DEVELOPMENT REVIEW BOARD REPORT

CASE NUMBER/ PROJECT NAME	92-DR-2005 Big O Tire Store		
LOCATION	7630 E. McDowell Road		
REQUEST	Request approval of site plan and elevations for a tire store.		
OWNER	Michelle Gruender 480-947-7229	ENGINEER	N/A
ARCHITECT/ DESIGNER	Architectural Team Three 480-968-6282	APPLICANT/ COORDINATOR	Bill Hunse Architectural Team Three 480-968-6282

SITE PLAN

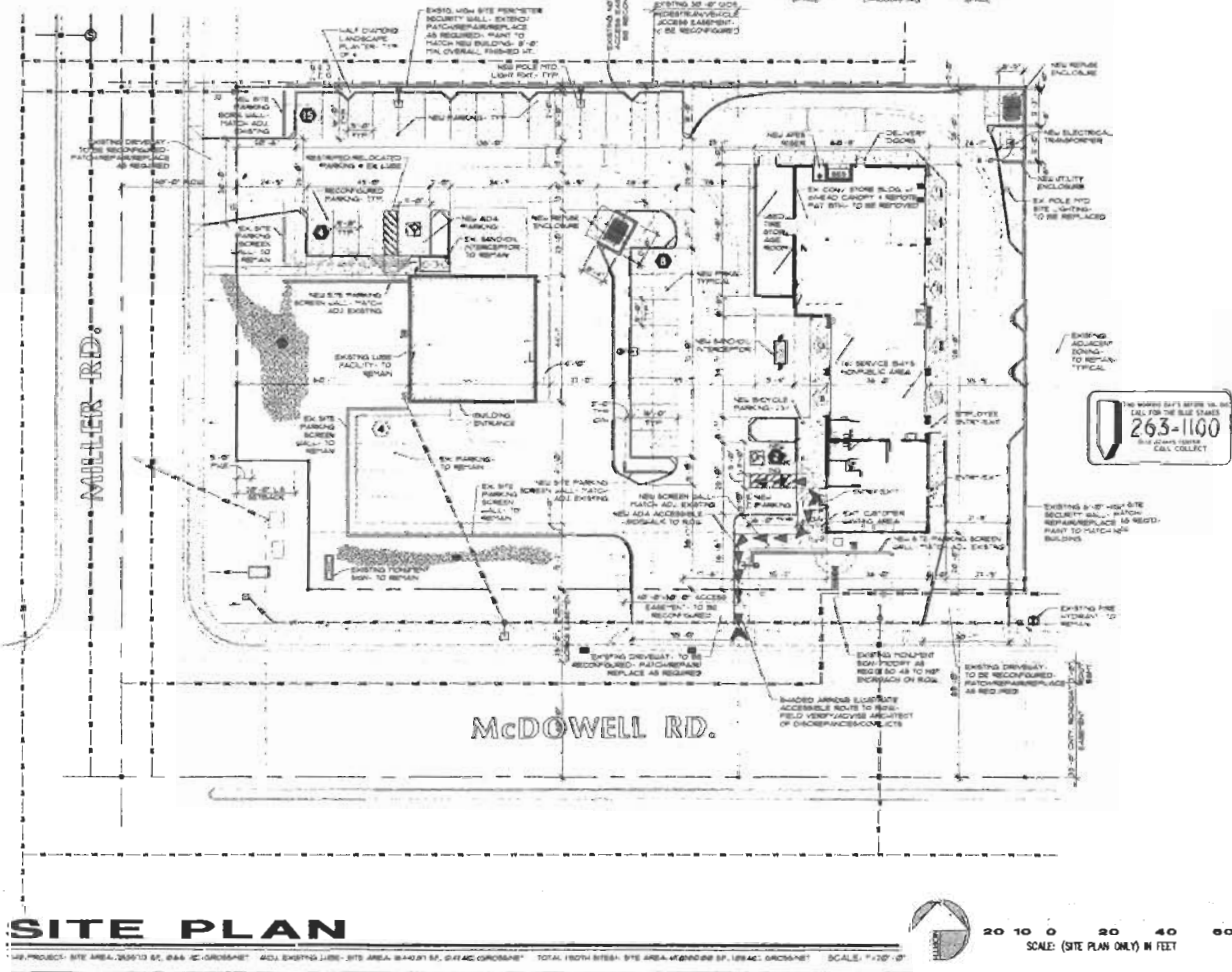
26. The developer shall design and construct the two driveways onto McDowell Road to be in general conformance with Standard Detail #2256 for CL-1 or 2257 for CH-1. The driveways shown on the currently proposed plans are too wide and need to conform to the standard details listed above.
27. The developer shall design and construct one driveway onto Miller Road to be in general conformance with Standard Detail #2256 for CL-1.
28. Provide min. 5-foot wide sidewalk from the site entrance of each building to the McDowell Road sidewalk.
29. Show bike parking on site.

30. The developer shall provide a minimum parking-aisle width of 24 feet.
31. The developer shall provide internal circulation that accommodates emergency and service vehicles with an outside turning radius of 45 feet and inside turning radius of 25 feet.
